# West Cambridge Development

## MASTER PLAN REVIEW

APRIL 2004

Forming an Amendment to:

2004 Master Plan Review  
Figure 100 rev A

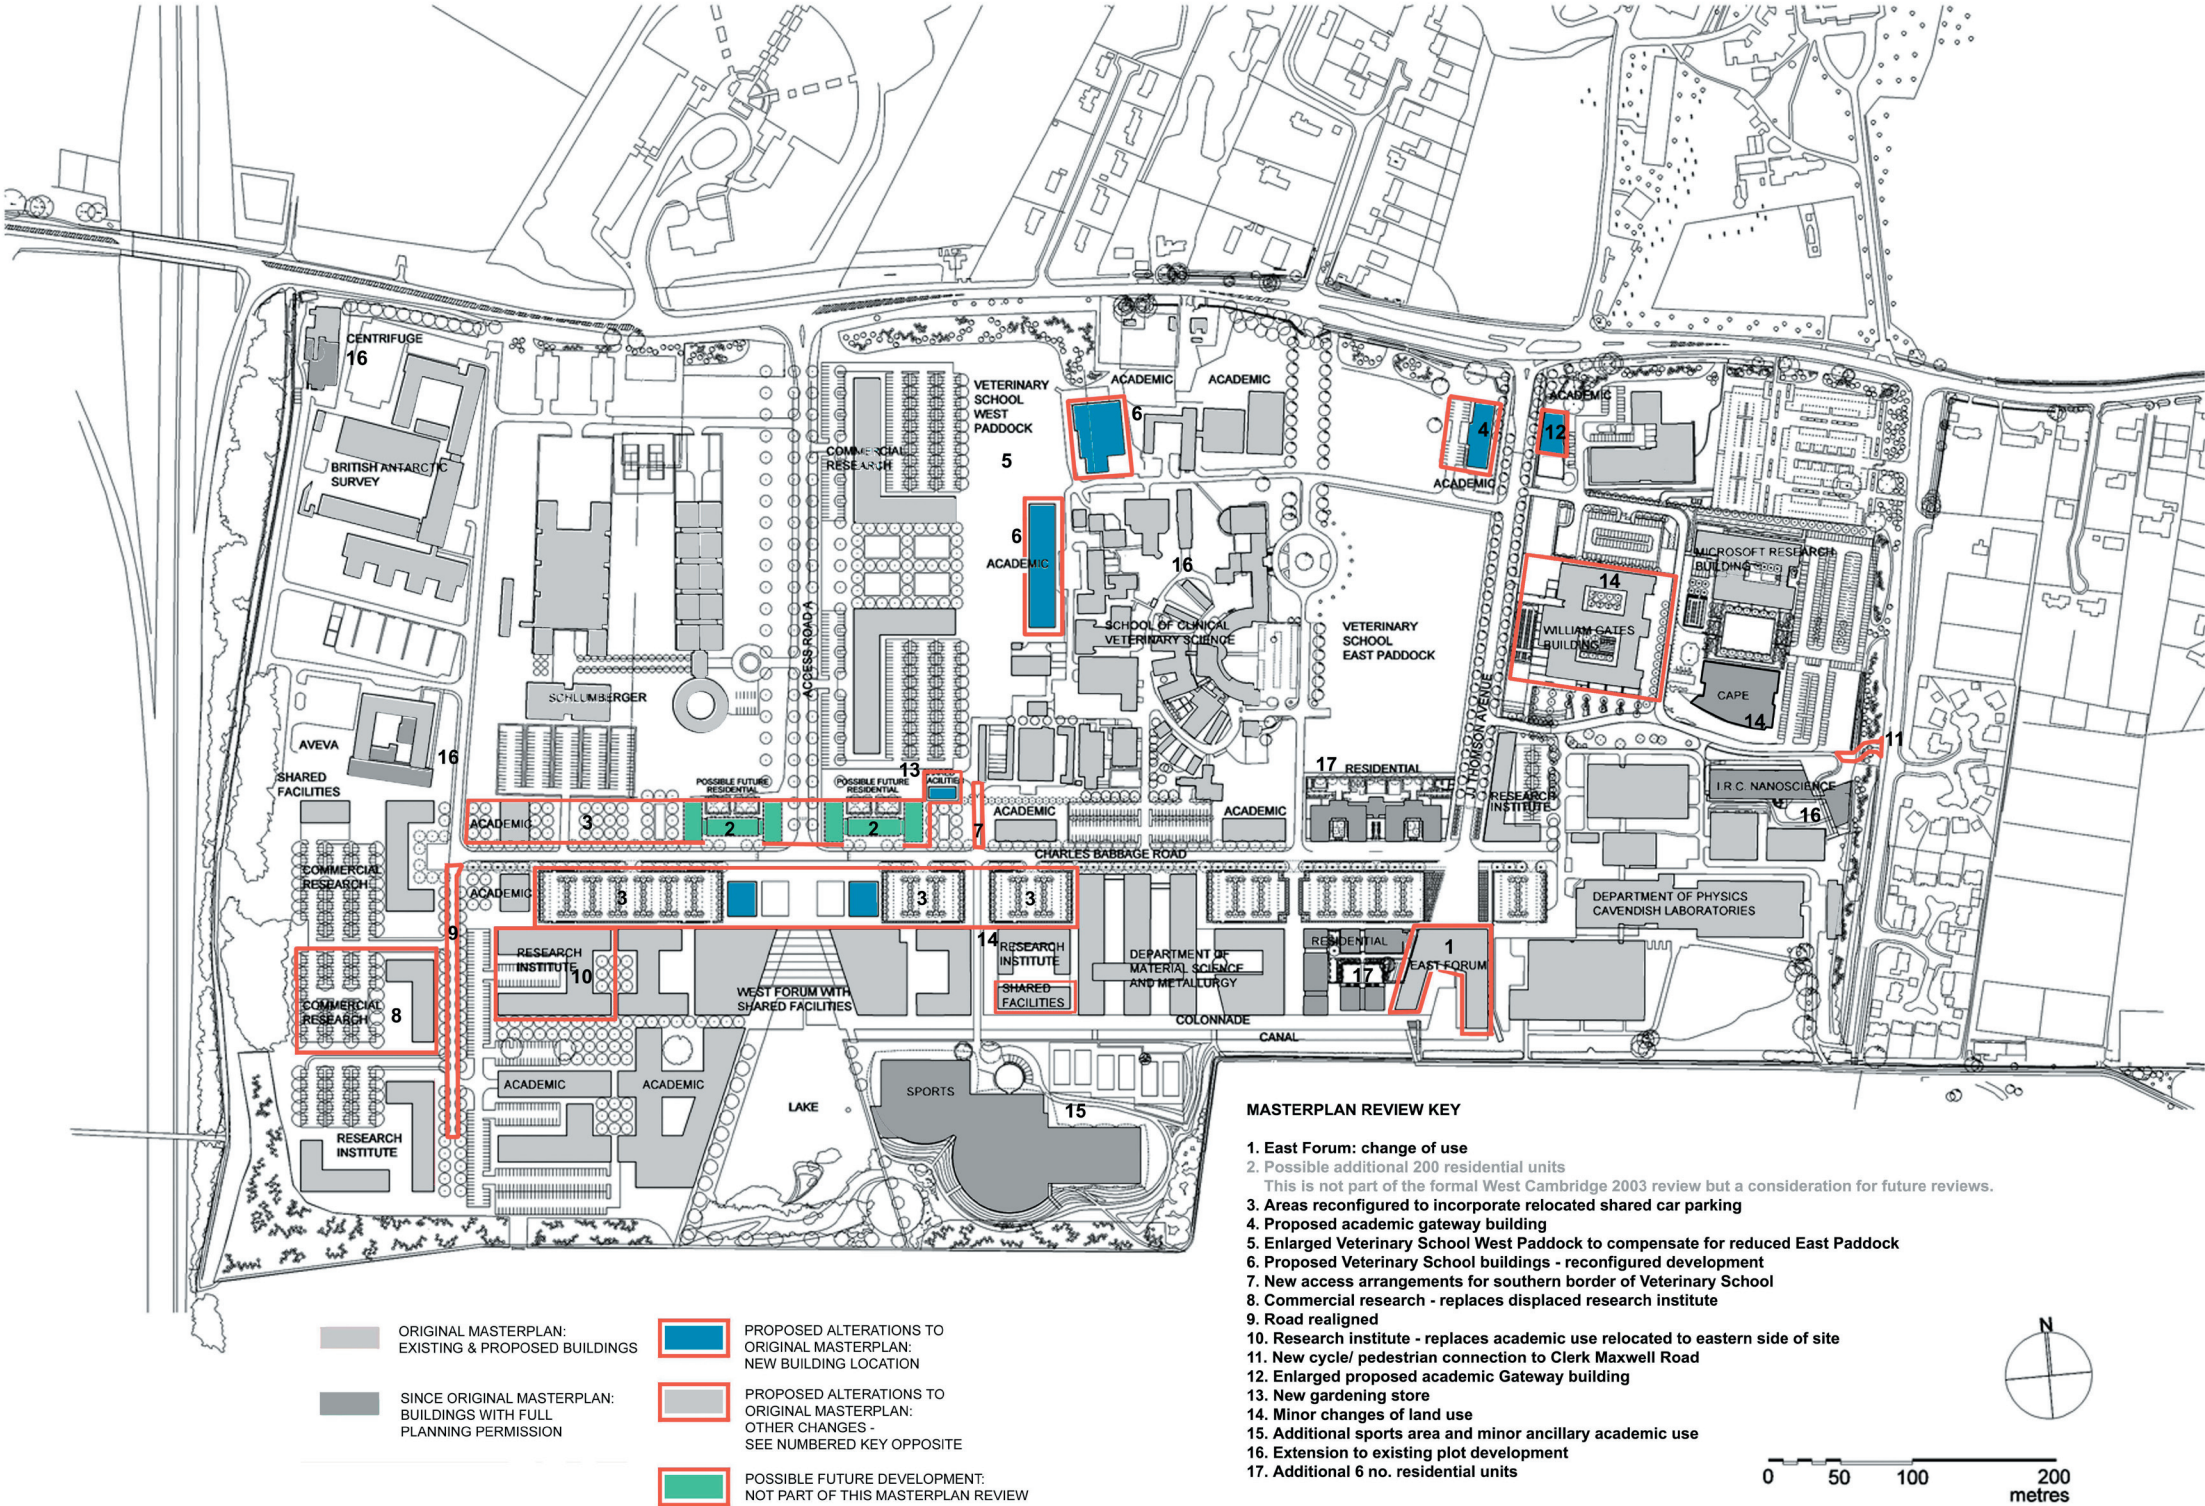
A number of projects have received Full Planning Approvals since 1999, which supersede the Outline Planning Approval. Some include minor amendments to the Master Plan. The 2004 Master Plan Review includes these amendments, to avoid discrepancies between the Master Plan Outline Planning Approval and the Full Planning Approvals for individual sites. The amendments are listed below:

1.2 South East area of Plot C (known as Centre for Advanced Photonics and Electronics or CAPE): Ref C/01/0526  
(Figure 101 rev A, key number 14)

1.3 Sports Complex, Plot B: Ref C/01/1229/FP  
(Figure 101 rev A, key number 15)

1.4 Residences and Nursery, Plot A2 and Part D: Ref C/02/0257  
(Figure 101 rev A, key number 17 and Figure 49 rev A)

1.5 Other Approved Developments  
(Figure 101 rev A, key number 16)

2.1 East Forum, Plot A2  
(Figure 101 rev A, key number 1 and Figure 6 rev A)

2004 Master Plan Review  
Location of City and County Wildlife Sites  
Figure 10 rev. A

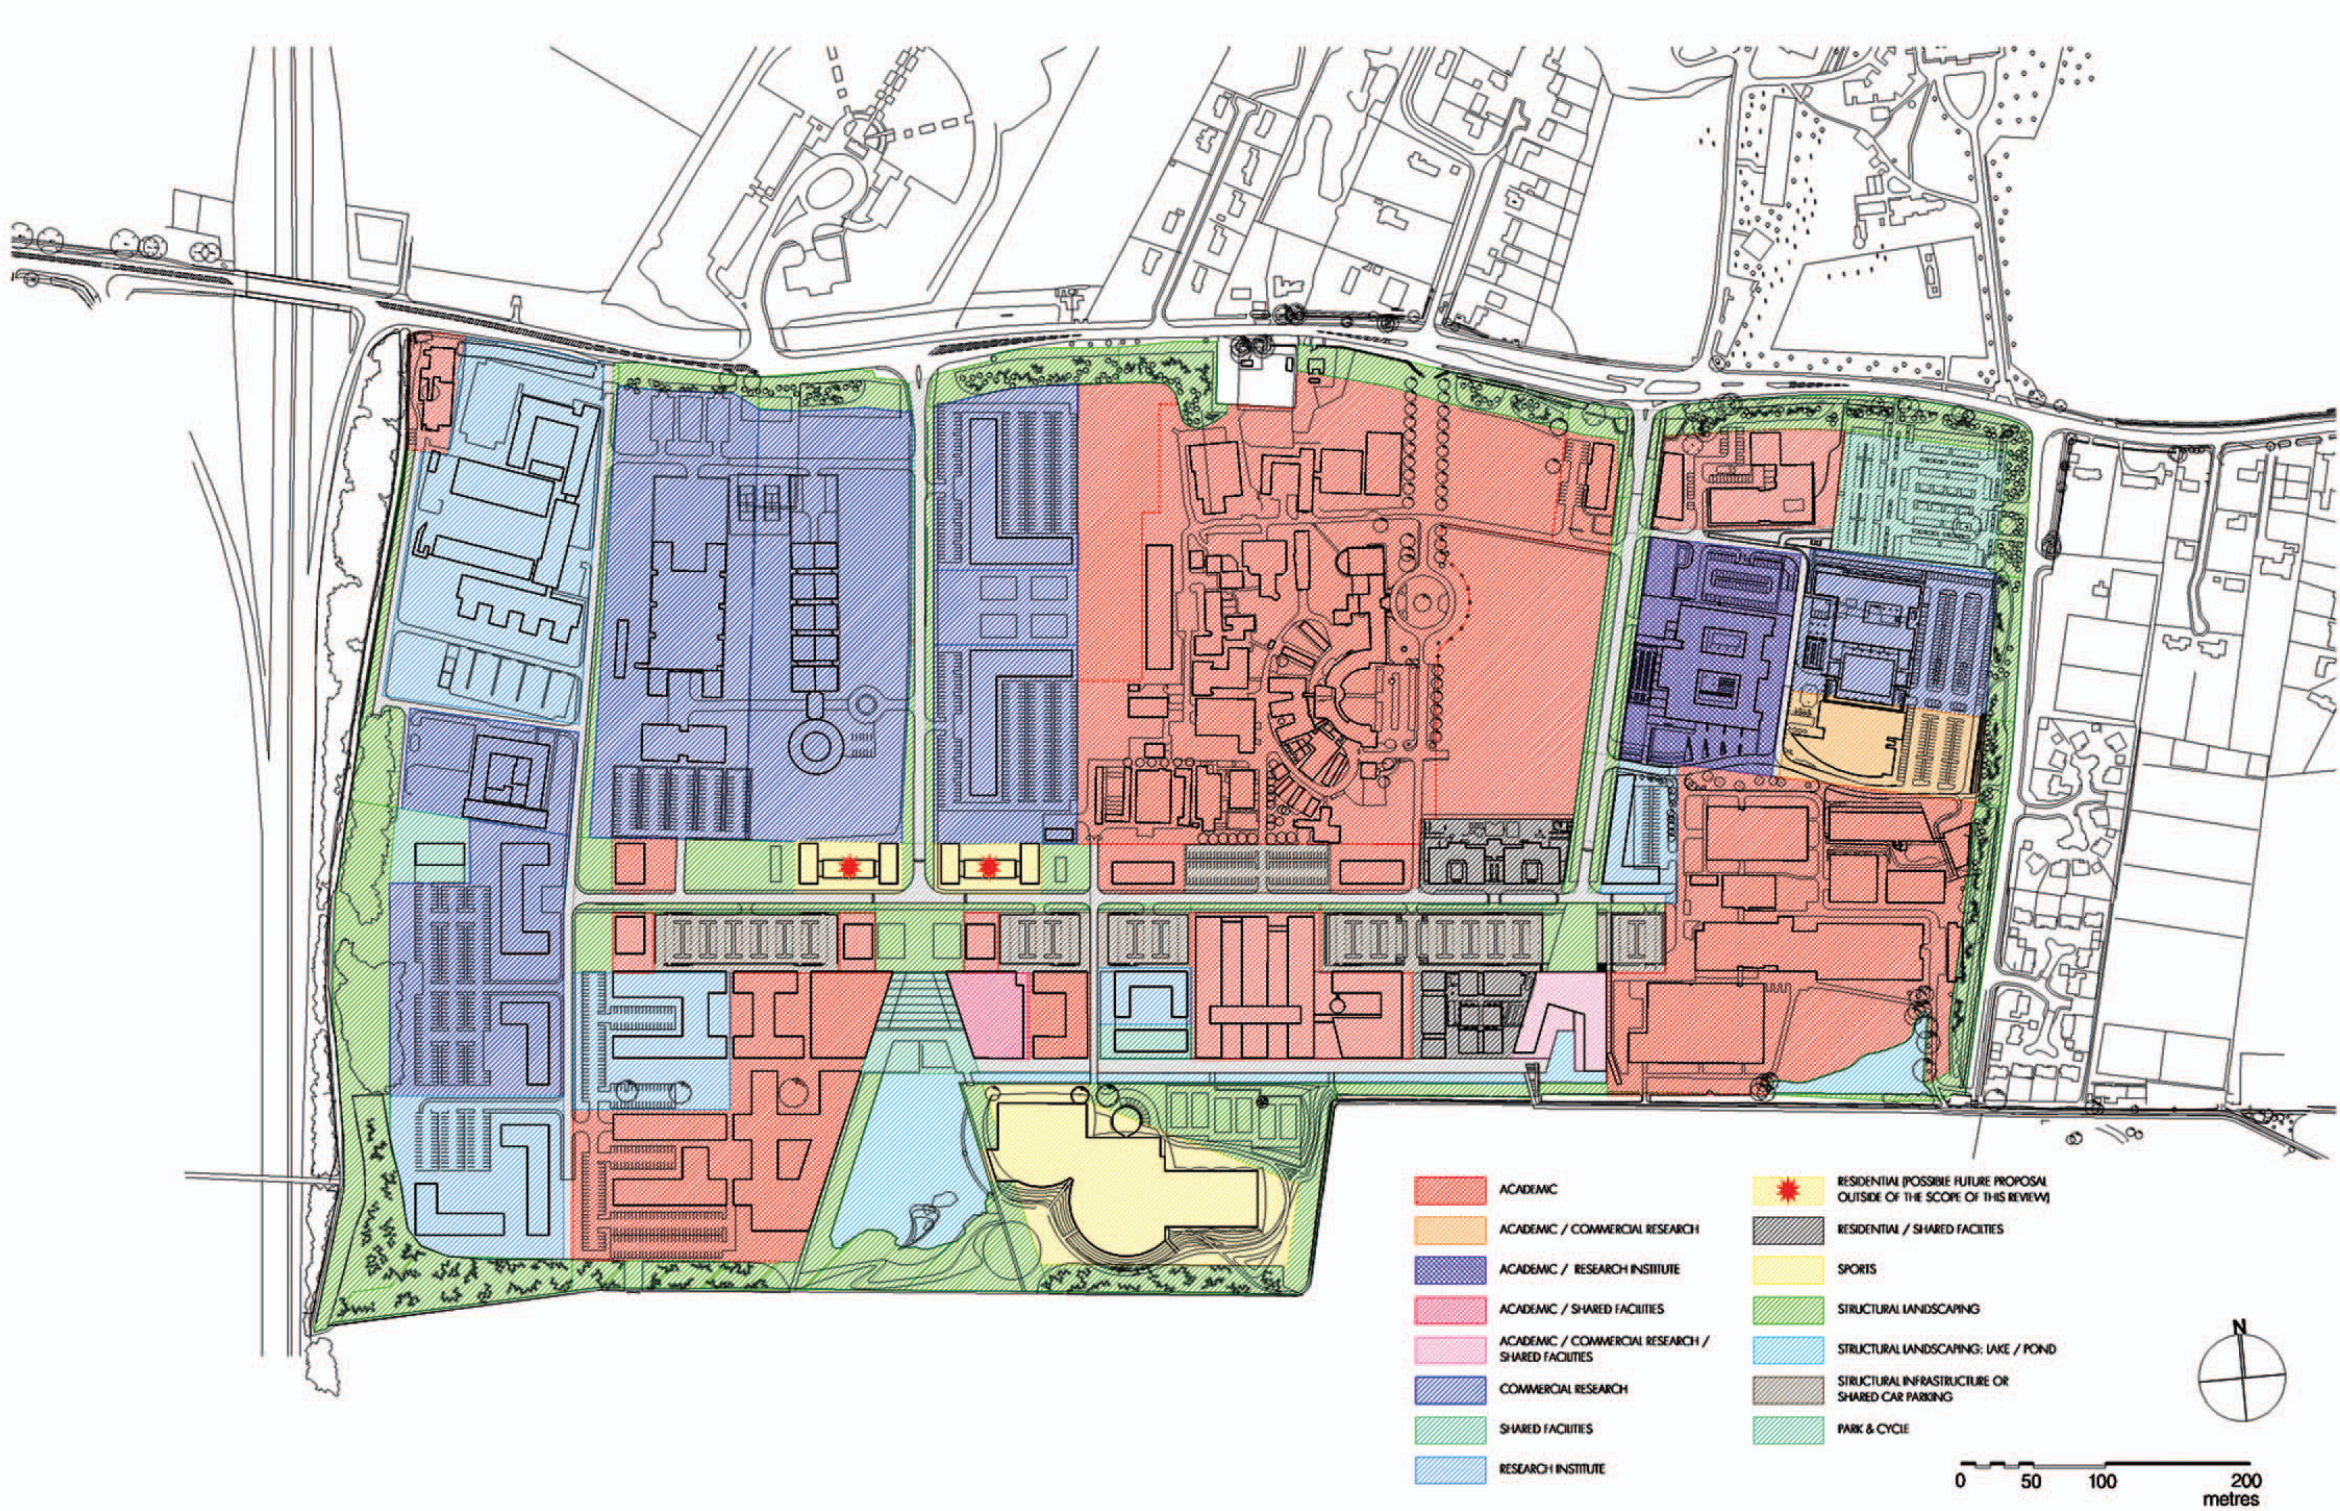
The Statutory Authorities have made some changes to the designation of City Wildlife Sites at West Cambridge, and these are shown on Figure10 rev A. They include alterations to the location of the County Wildlife Site on Plot B, and the de-registration of Paynes Pond, which is no longer a City Wildlife Site, on Plot A3.

There has been a change to the designation of Wildlife Sites at West Cambridge. This is shown in Figure 10 Rev A – “Location of City and Country Wildlife Sites” included in the 2004 Review, and supersedes the locations shown on Figures 3 and 10, and described in Part 3, Clause 3.54 of the original Master Plan and Environmental Statement.

2004 Master Plan Review  
Illustrative New Land Use  
Figure 21 rev. B

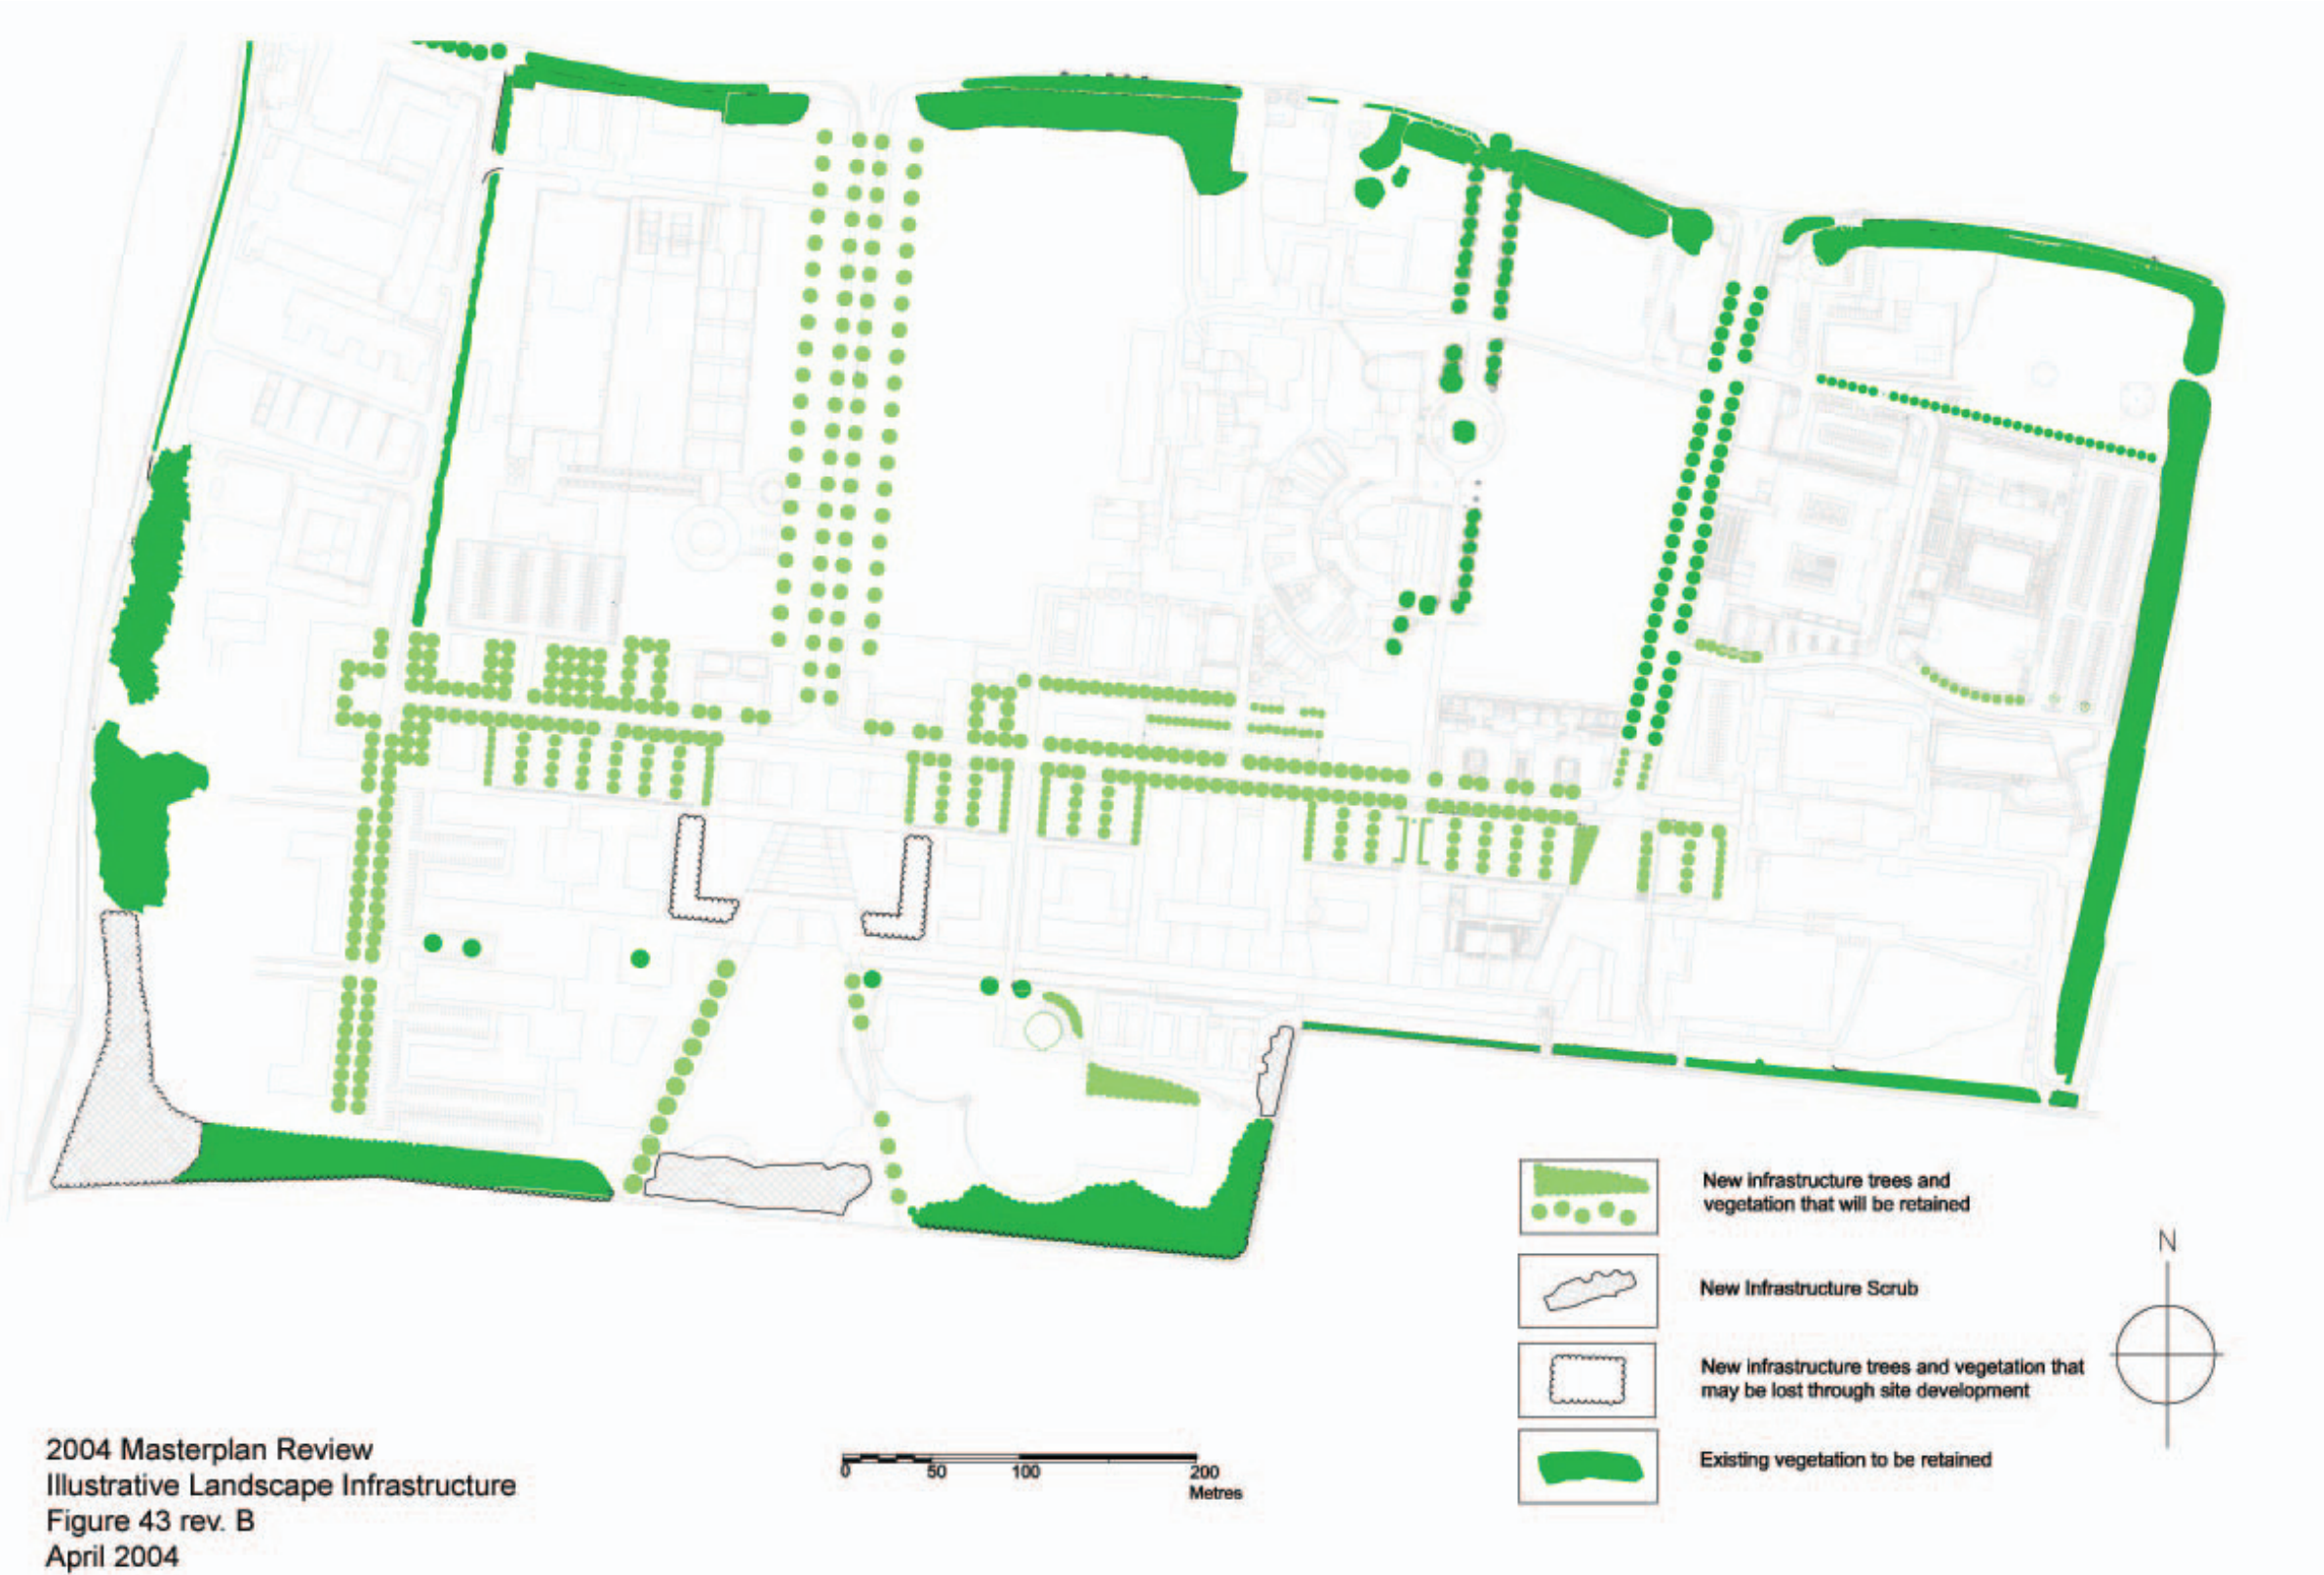
Clause 4.35 to be amended as follows:  
*"Larger sites for commercial research organisations are located on main access roads and, where possible, closer to Madingley Road, to limit the extent to which employees' cars will penetrate the main area of new academic development in the south of the site, which is intended to be a pedestrian/cycle dominated environment. (Figure 21, rev B)."*

**Fig 21:** Illustrative New Land Use – Updated, see Figure 21 Rev B  
**Fig 22:** Key Elements of the Master Plan – No change to Master Plan proposals
